# ALERT SERVICE BULLETIN

NO. 205B-09-53

**SUBJECT:** 205-030-856-157/-159 ELEVATORS, ONE TIME INSPECTION OF.

**HELICOPTERS AFFECTED:** Model 205B helicopters with 205-030-856-157/-159 elevators, s/n A-1587 through A-1862 installed.

**Figure 1**  
Angle Measurements

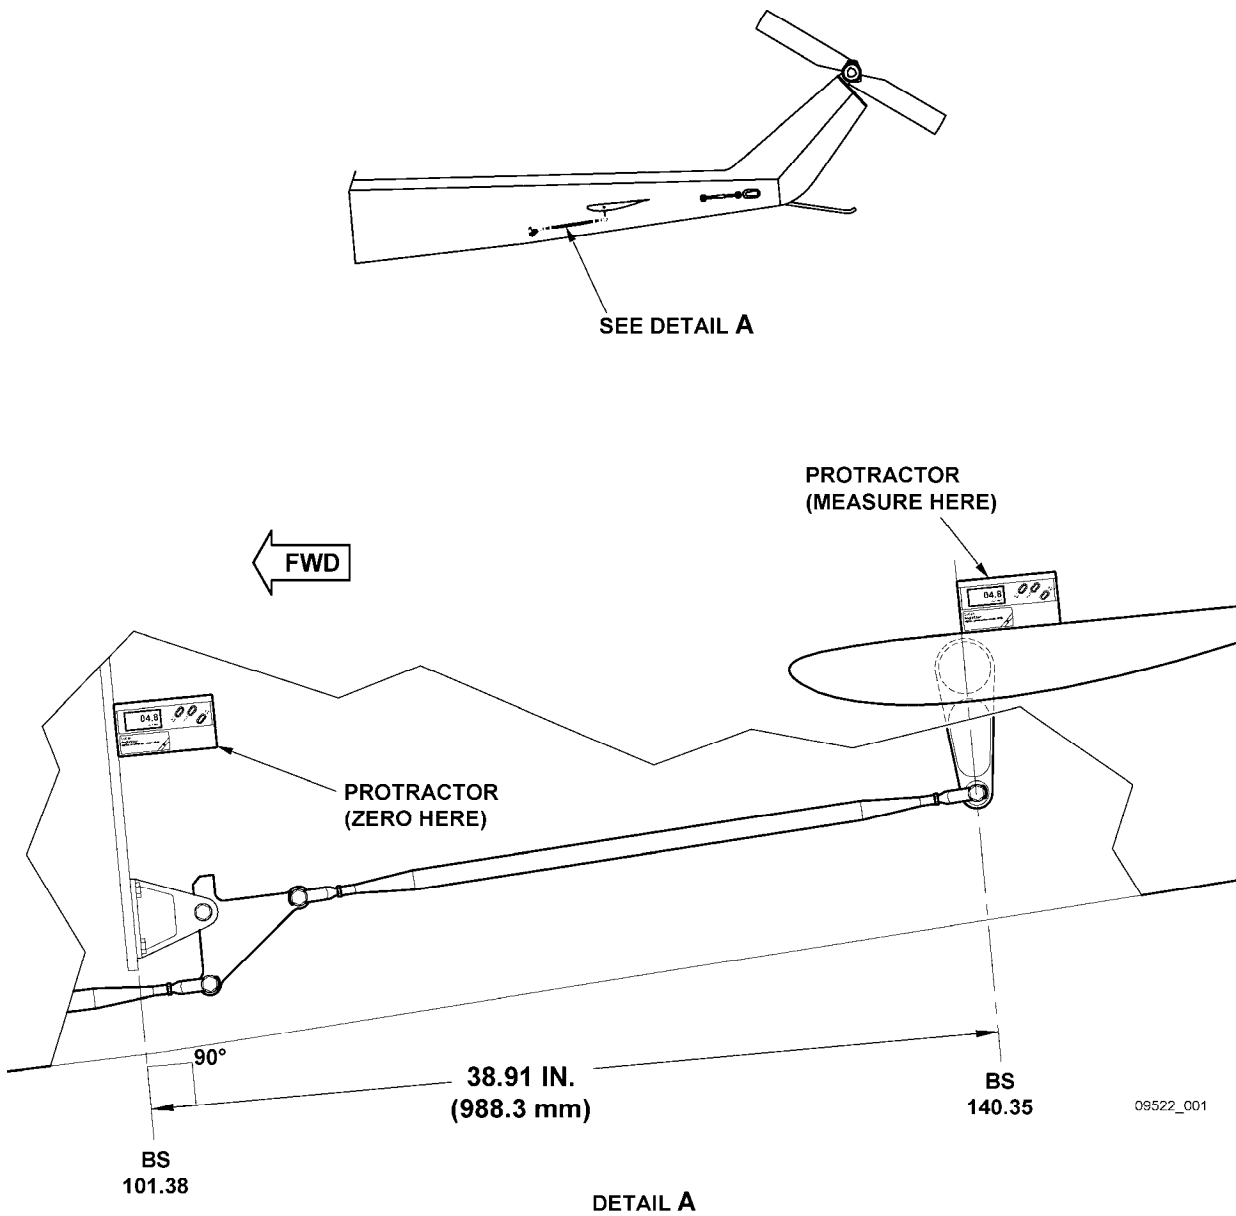
1. Prepare helicopter for maintenance.
2. Confirm any of the elevators are within serial number range by referring to their bonded and riveted dataplate near the trailing edge.
3. Remove tailboom belly access panel just aft of Boom Station (BS) 101.38.
4. Using a measuring tape, position center of elevator horn control bolt at 38.91 +/- 0.03 inches (989.8 +/- 0.8 mm) from (and perpendicular to) the aft face of bulkhead at BS 101.38. Refer to Figure 1. Move cyclic controls as required and apply cyclic control friction when done.
5. Place digital protractor on aft face of bulkhead at BS 101.38. Zero protractor.
6. Move protractor to top skin of RH elevator second rib, edge of protractor should be aligned with the 8<sup>th</sup> rivet from the leading edge of the elevator. Record relative angle as Angle "A". Zero protractor.

7. Move protractor to top skin of L/H Elevator and record the angle as Angle "B".

8. The correct value for Angle A is 0.00 +/- 0.50 degree. The correct value for Angle B is 3.00 +/- 0.75 degree.
  - a. If Angle "A" and Angle "B" are not within their applicable tolerance, replace the RH elevator as per Maintenance Manual within the next 100 flight-hours and proceed to Part II thereafter.

- b. If Angle "A" is not within its applicable tolerance but Angle "B" is within its applicable tolerance, replace the RH elevator as per Maintenance Manual within the next 600 flight-hours and proceed to Part II thereafter.

- c. If Angle "A" is within its applicable tolerance but Angle "B" is not within its applicable tolerance, replace LH elevator as per Maintenance Manual within the next 100 flight-hours. No further action is required. Go to Part II, step 6.

- d. If Angle "A" and Angle "B" are both within their applicable tolerance, both elevators are compliant and no further action is required. Go to Part II, step 6.
